**BEFORE THE HEARINGS PANEL
FOR THE QUEENSTOWN LAKES PROPOSED DISTRICT PLAN**

IN THE MATTER of a private plan change to the
Queenstown Lakes Proposed
District Plan: Proposed Private Plan
Change 1 The Hills Resort
Zone

**STATEMENT OF EVIDENCE OF ANTONI PETER FACEY
ON BEHALF OF QUEENSTOWN LAKES DISTRICT COUNCIL**

**TRANSPORT
13 FEBRUARY 2026**

Image 1: Aerial photo of battering work required at Hogans Gully Road to create a 115 metre sight distance

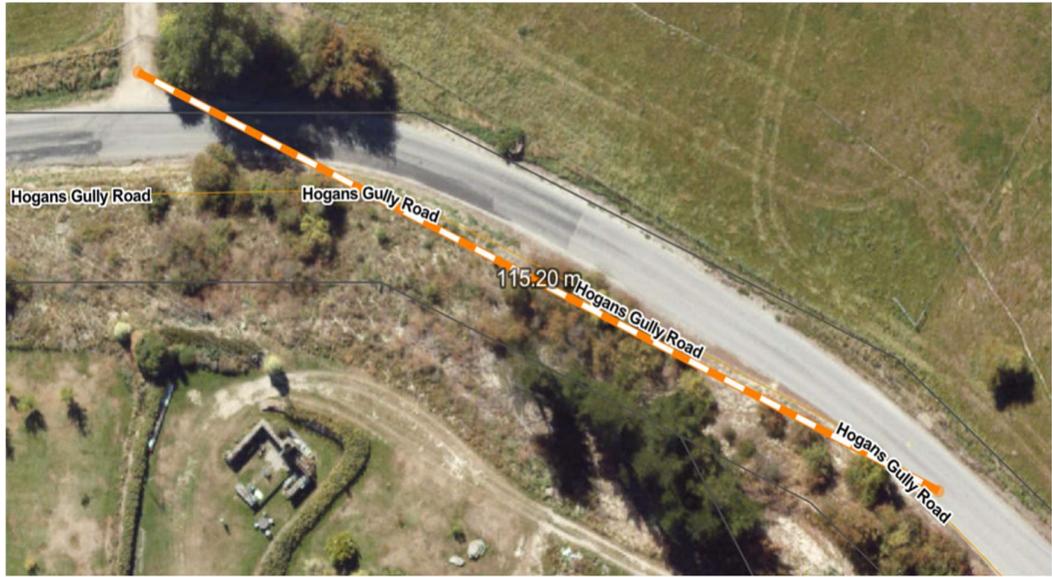
- 3.14 It should also be noted that the eastern approach to the access is downhill and although the PDP does not have a correction for grade, AUSTRROADS Guide to Road Design Part 4A “Unsignalised and Signalised Intersections” Table 3.4 would add an additional 10 metres to the required sight distance for a design speed of 60 km/hr to account for the downhill grade. This would make the required sight distance 115 metres. In my view, adding the correction for grade should be standard technical practice.

- 3.15 The aerial photo in Image 1 below approximately shows the amount of battering work required to create a 115 metre sight distance. There is no certainty that such a batter could be provided within the road reserve given the steepness of the existing bank.

- 3.17 Therefore, I conclude that there is a safety risk associated with the location of the existing access that will be elevated by the increase in traffic using the access compared to the existing use as farm access. There is no certainty that the Requestor could achieve the minimum sight distances required by cutting back the bank on the inside of the curve.

Image 2: Aerial photo of alternative access location

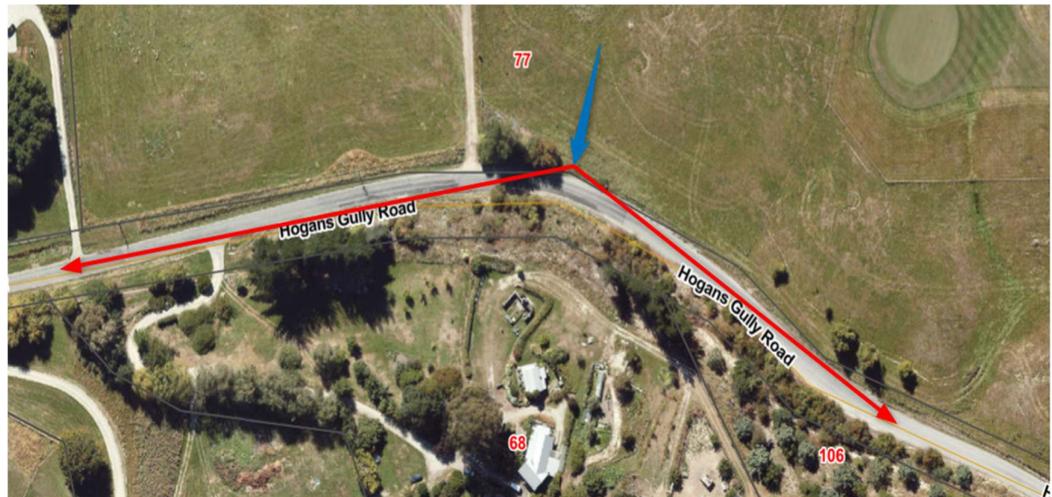
- 3.18 For these reasons, I considered if there were alternative sites available that would be safer and meet the basic sight distance criteria in the PDP. I noted that approximately 35 metres to the east is a potential location for a vehicle access that would meet the sight distance criteria. This is shown on the aerial photograph in Image 2 below. The blue arrow shows the potential location of the access while the red arrows show the sight

distance. The minimum sight distance to the east (left) is about 135 metres and can be increased, if necessary, across the Requestors boundary.

3.19 My view is that the existing vehicle access location should not be accepted and a new access location included in the Structure Plan as shown in the aerial photo above. This new location would meet the sight distance requirements. Under Rule 47.4.1 of the PDP, the design elements of the vehicle access will be subject to the detailed requirements of Chapter 29 of the PDP. This can be assessed at the resource consent or Engineering Acceptance stages. There may be other locations that can also provide the required sight distances but the Requestor has proposed only the existing access which I consider would be unacceptable.
